Re: Florida Power & Light Company
Turkey Point Units 3 and 4
Docket Nos. 50-250 and 50-251
Turkey Point Units 3 and 4 Subsequent License Renewal Application
Environmental Review Requests for Additional Information (RAI) Set 3 Responses

NRC RAI Number: HC-7-a

NRC RAI Number: WR-2-a

**Pump Data Sheet – American-Marsh Pumps
(November 19, 2014)**

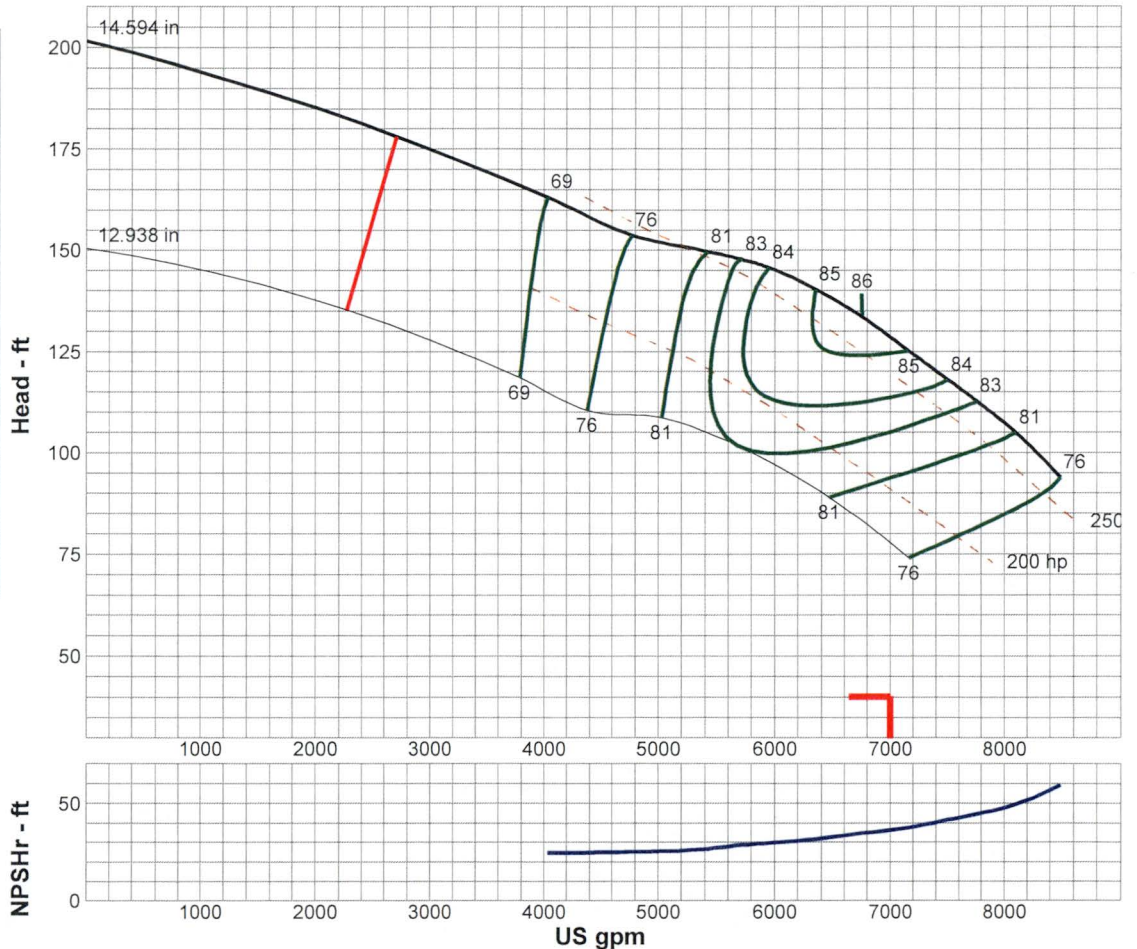
verification of when each well was installed or converted for production purposes, well diameter, casing depth and type, total depth, open hole or screening interval (as applicable), and installed pump capacity.

Marine well PW-1 is equipped with a single stage vertical turbine pump capable of pumping 7,000 gallons per minute (gpm) at an installed depth of 40 feet. The data sheet for the pump installed in marine well PW-1 is provided in Enclosure 1.

FIGURE TITLE: WELL CONSTRUCTION DIAGRAM

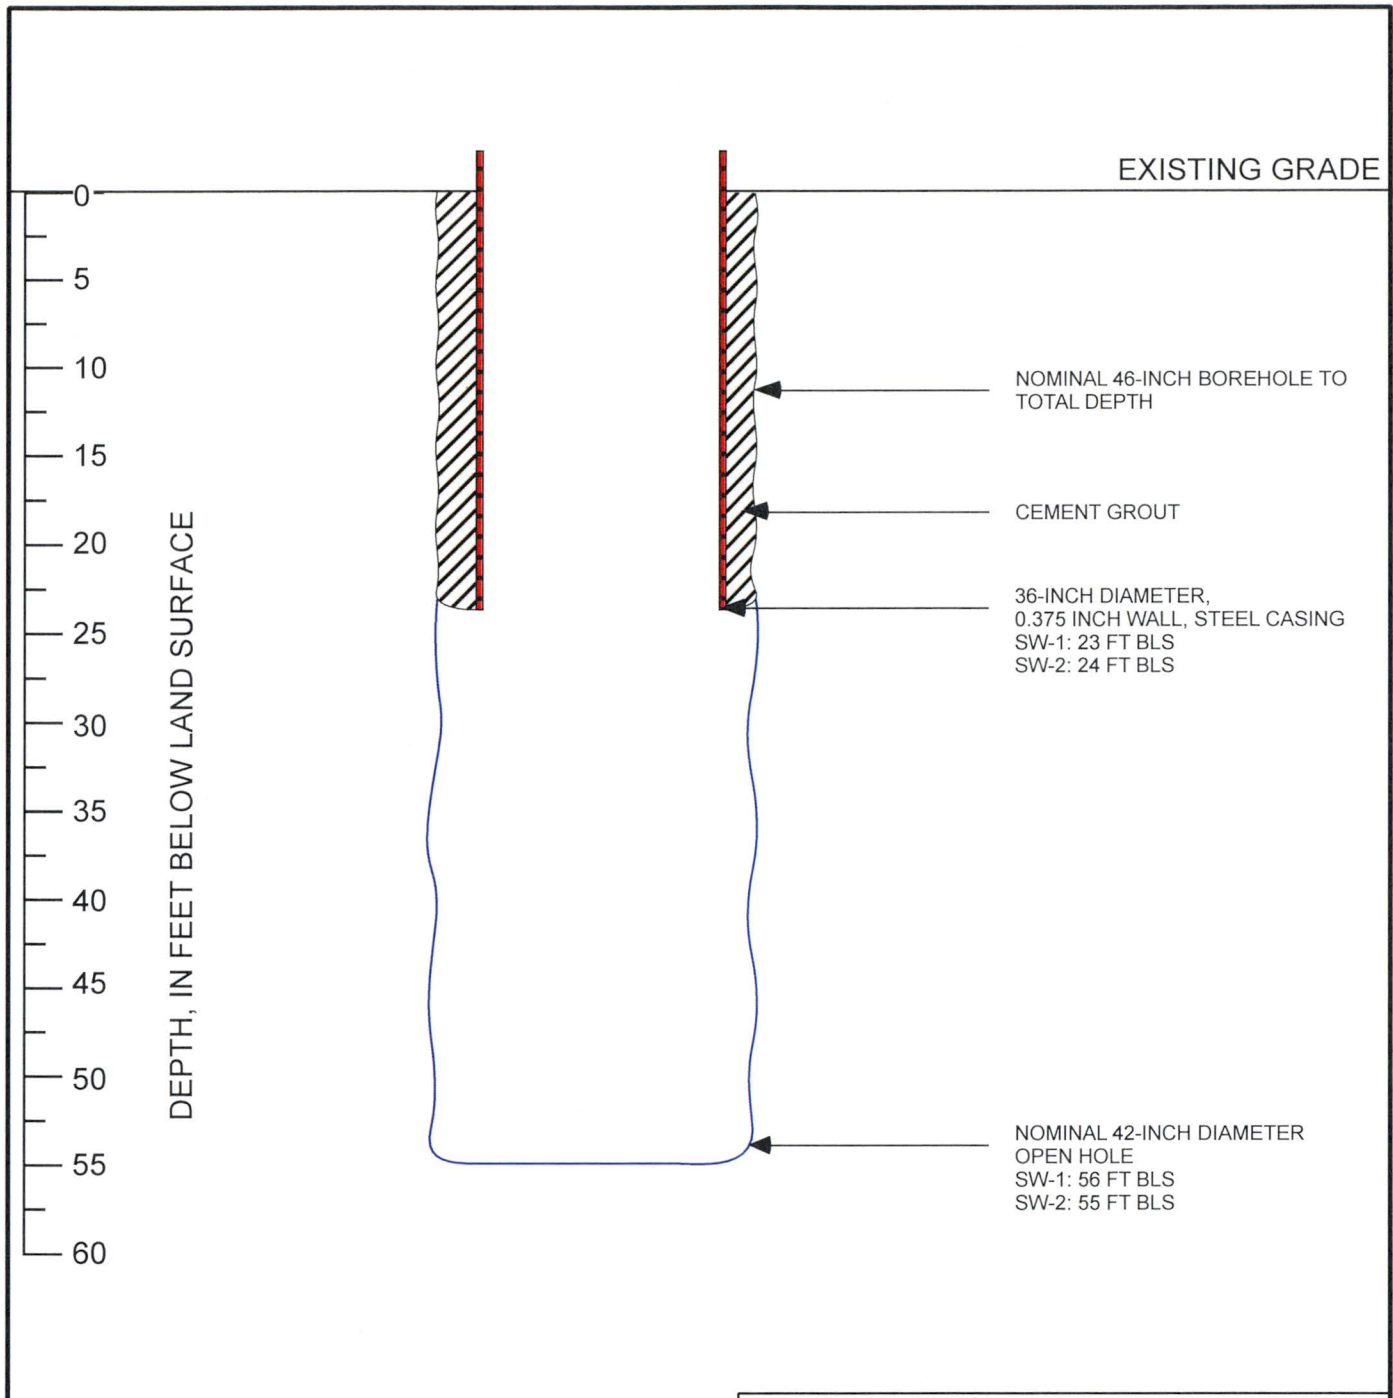
FPL's supporting response to NRC RAI No. WR-2, included in L-2018-136 Attachment 43, Enclosure 20 (ADAMS Accession No. ML18247A507) indicates that "Marine" wells SW-1, SW-2, and PW-1 located on the Turkey Point peninsula have been in use as recently as August 2017, presumably to support cooling canal system freshening. While the Environmental Report states that the wells were installed in 2015 and produce saline water, little additional information is included on the three wells. Other available information indicates that at least one of the wells, PW-1, was constructed to support aquifer performance testing in 2009. In order to assess the environmental impacts of these wells, the staff needs additional information and clarification. Specifically, the NRC staff requests additional information on the construction of these wells including:

A general construction diagram, well construction details, step drawdown test, water quality results, and lithologic logs for marine wells SW-1 and SW-2 are provided in Enclosure 2.

As detailed in Enclosure 2, marine wells SW-1 and SW-2 were installed in early 2015 with the current pump and piping arrangement.

Marine wells SW-1 and SW-2 are equipped with three stage axial flow pumps capable of pumping 12,500 gpm each at an installed depth of 75 feet. Marine well SW-1 is completed with an open borehole between 23 feet and 56 feet below land surface (bls). Marine well SW-2 is completed with an open borehole between 24 feet and 55 feet bls. Therefore, the pumps are installed at depths shallower than 75 feet bls. Based on the pump performance curve, the installed pumps are capable of pumping 15,000 gpm each at 45 feet bls.
